DOE/EA-1050
May 1996

Environmental Assessment

Test Area North Pool Stabilization Project

**U. S. DEPARTMENT OF ENERGY
FINDING OF NO SIGNIFICANT IMPACT FOR THE
TEST AREA NORTH POOL STABILIZATION PROJECT
AT THE IDAHO NATIONAL ENGINEERING LABORATORY**

Figure 10. Sierra Nuclear Ventilated Storage Cask (VSC-24).

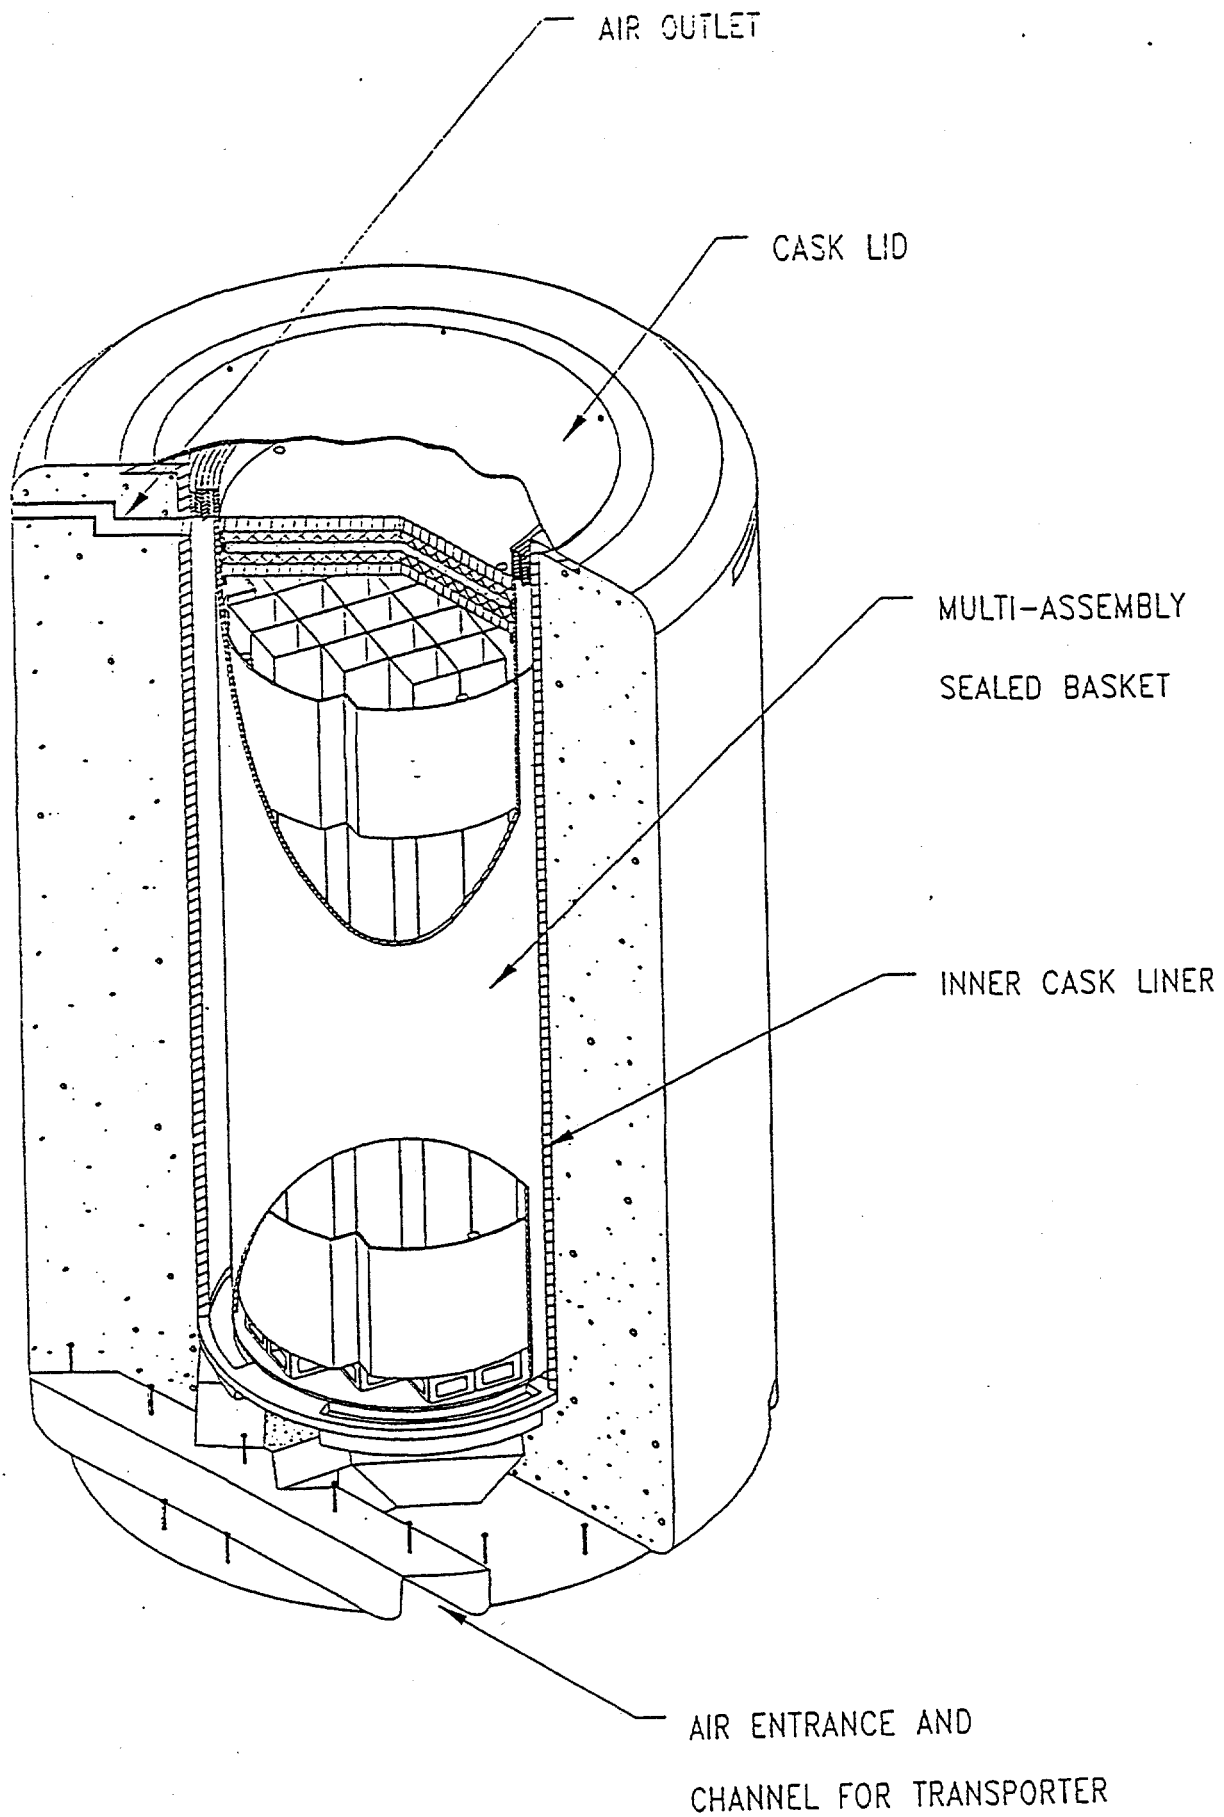
7. Comment: The statement is made that there are several types of ISS facilities available that could be modified to accommodate the TMI core debris and provides some description of them. DOE needs to provide more specific detail for the decisionmaker and the public to evaluate this issue.

Response: Figures 5 through 10 have been added to the EA to identify various existing commercial dry SNF storage systems that could be available. Any existing design would require modifications to accommodate the unique requirements of the TMI core debris. The extent of modifications required is not known at this time, since procurement of a storage system has not yet occurred. The environmental impacts of these different hypothetical designs do not differ from one design to the next.
